**DEPARTMENT OF TRANSPORTATION  
STATE OF GEORGIA**

**FILE:** EDS-84(26), HPPN-EDS-84(27) & NHN-007-03(28) **OFFICE:** Eng. Services  
Ware County  
P.I. Nos.: 522770, 522780 & 522775  
S.R. 38/U.S. 84 Widening/Reconstruction and Bridge Replacement

**SUBJECT: IMPLEMENTATION OF VALUE ENGINEERING STUDY ALTERNATIVES**

# VALUE ENGINEERING STUDY REPORT RESPONSES

VE Comment A-2  
Original Layout

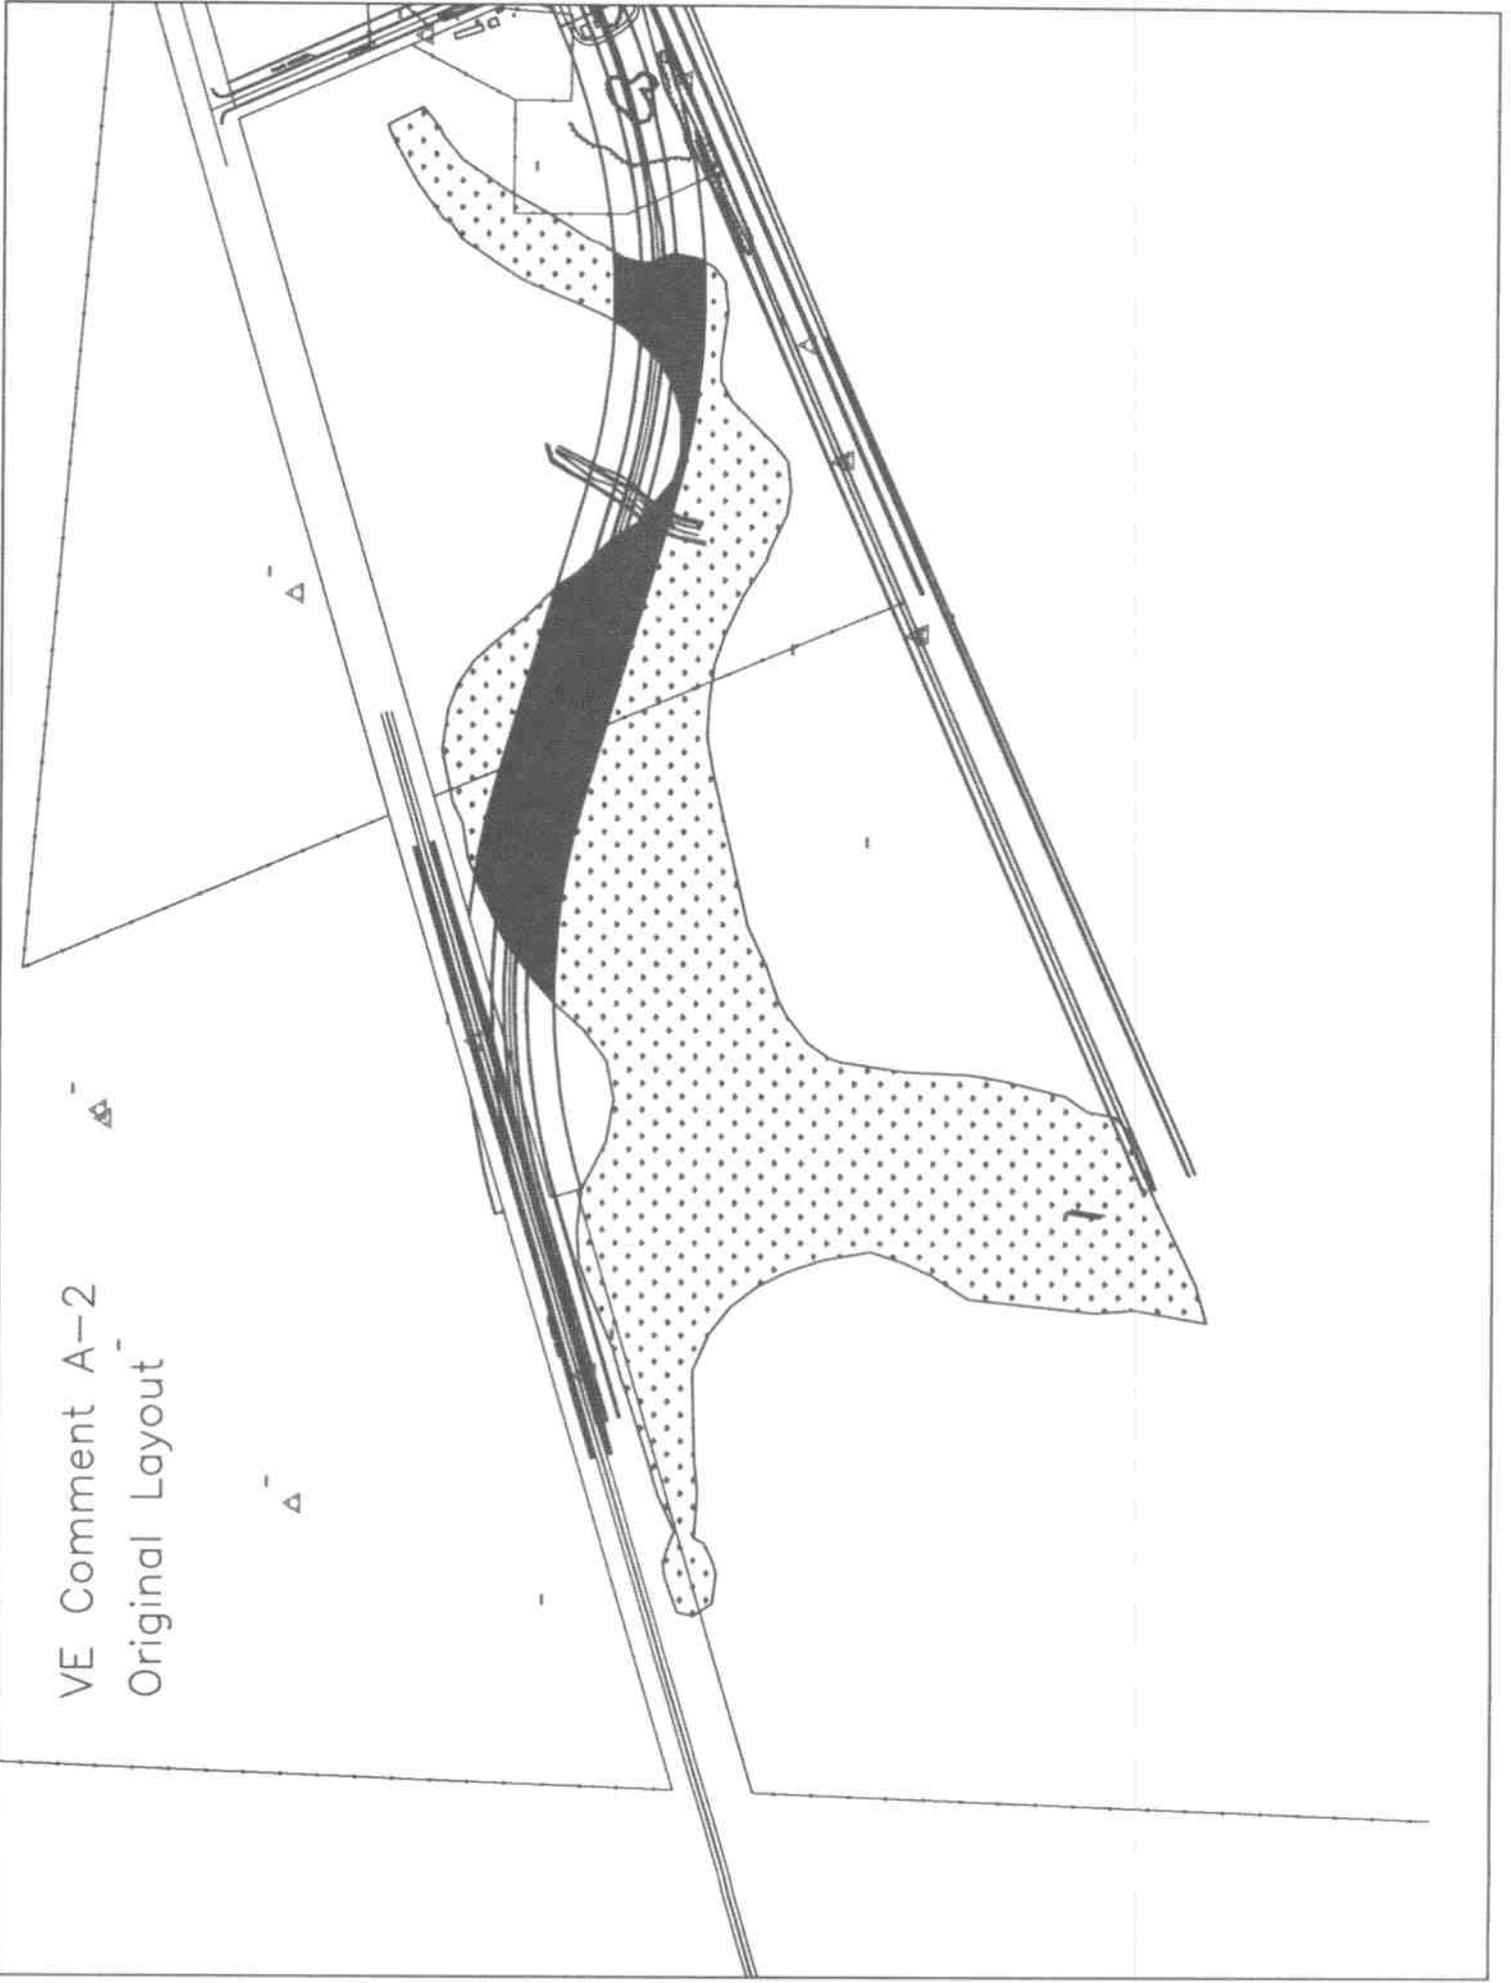
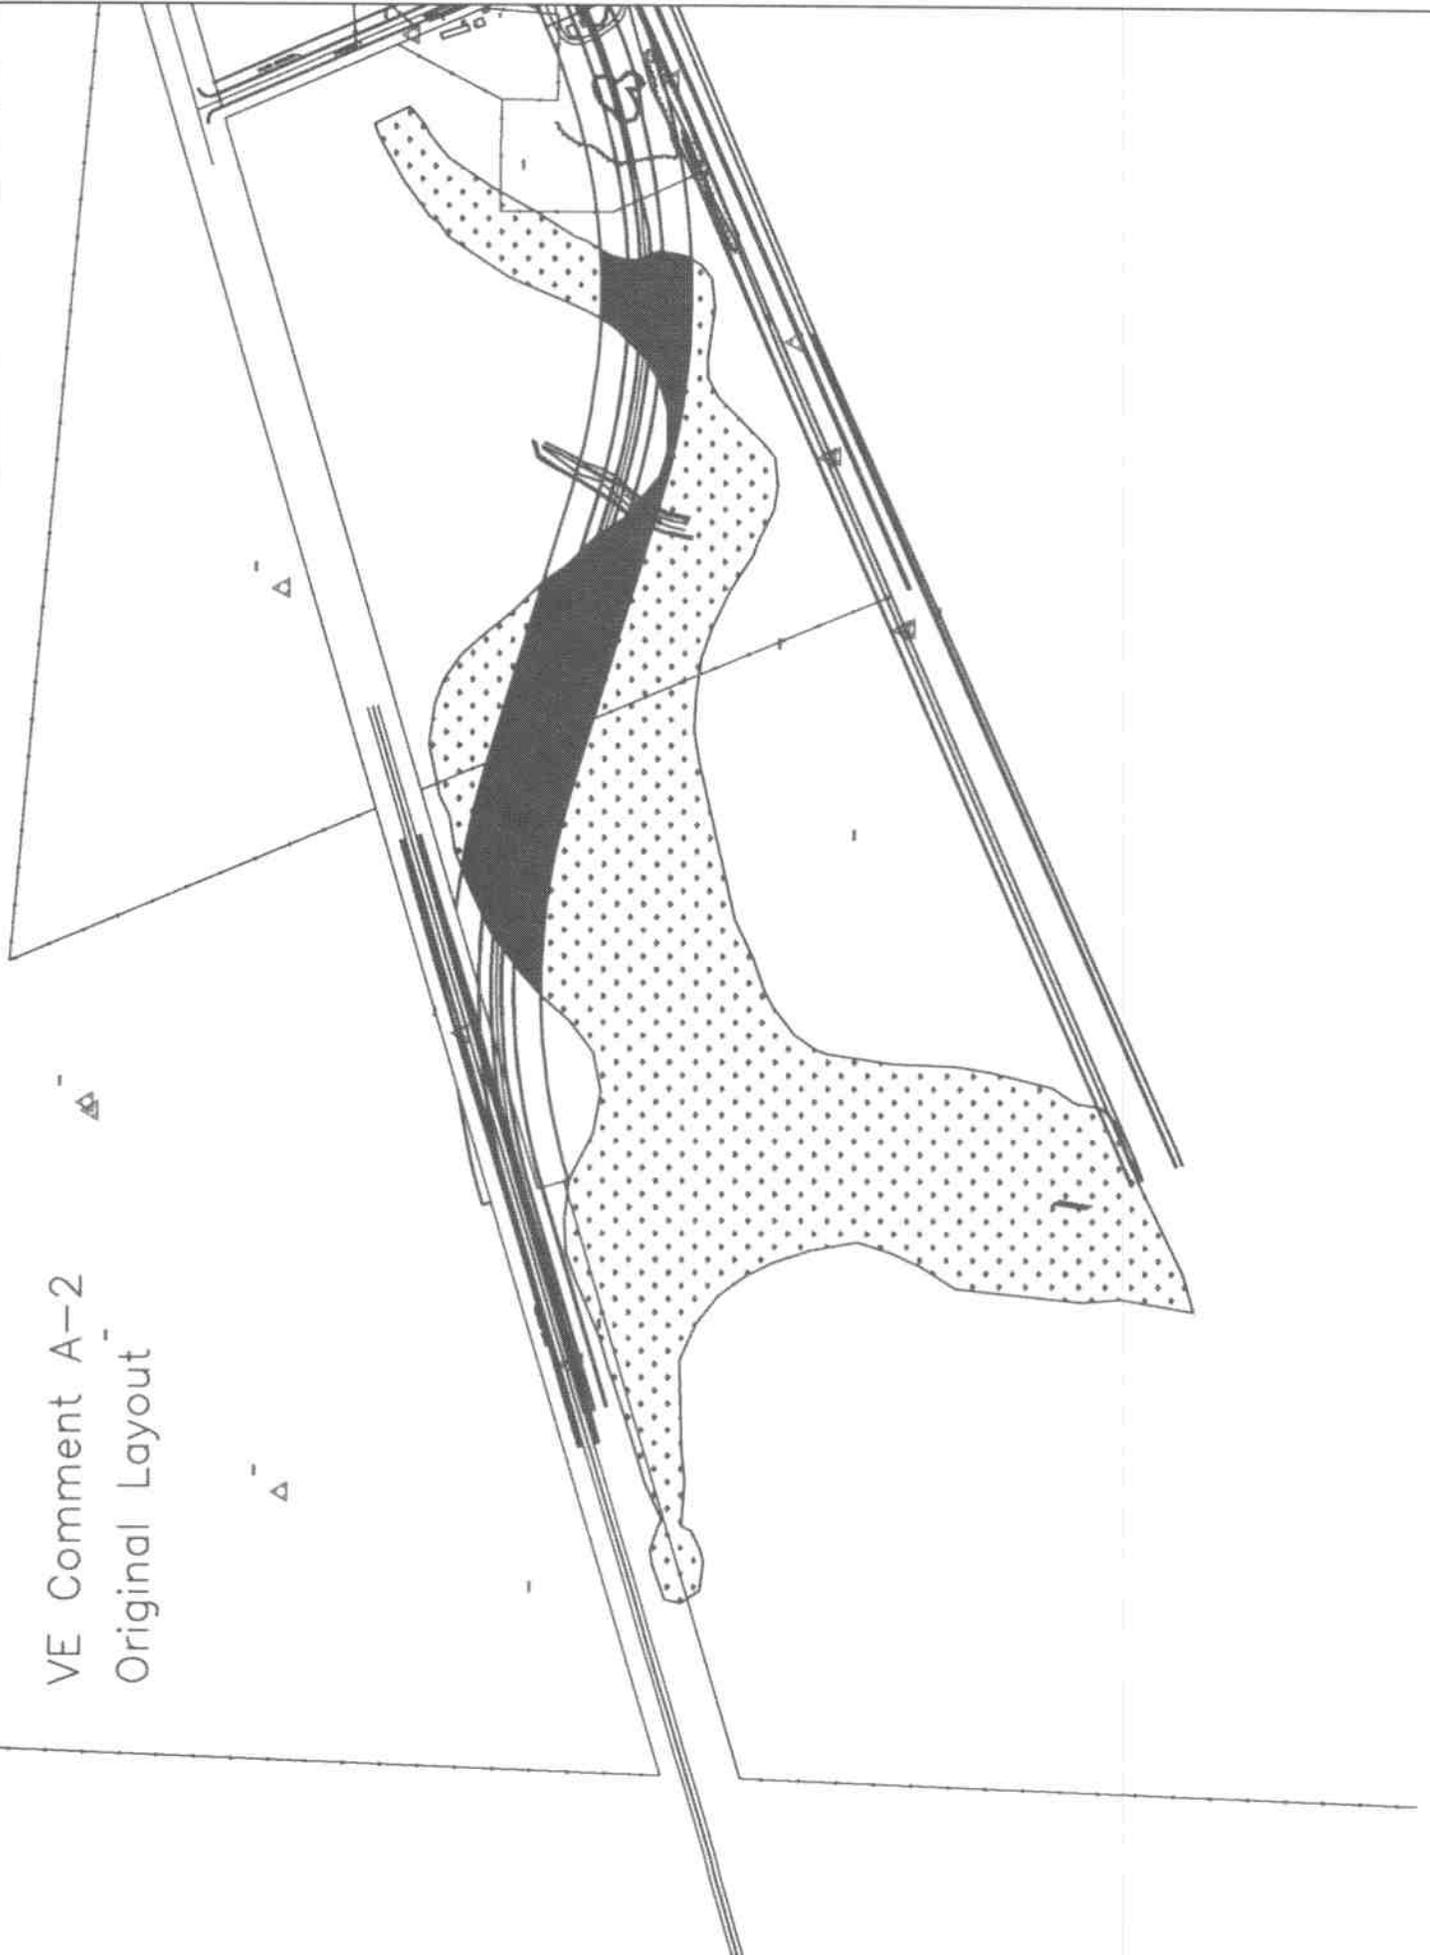
A-2 Reduce impacts to wetlands with new alignment at west end (increase wetlands identification) DS

The wetland areas shown on the plans are not inclusive of all areas other than those impacted by the original corridor. The actual area of wetlands in the surrounding vicinity is much larger. Therefore if the alignment were to be relocated as suggested by this comment, the impacts to wetlands would not be decreased as significantly as it would appear. For the first option the reduction would be 1.73 acres and for the second option the reduction would be 3.71 acres. Furthermore, the overall project costs will be increased due to the increase in required right-of-way as well as the increase in the new location paving quantities. The increase for the first option would be \$274,235 and for the second option the increase would be \$371,700. (See A-2 attachments)
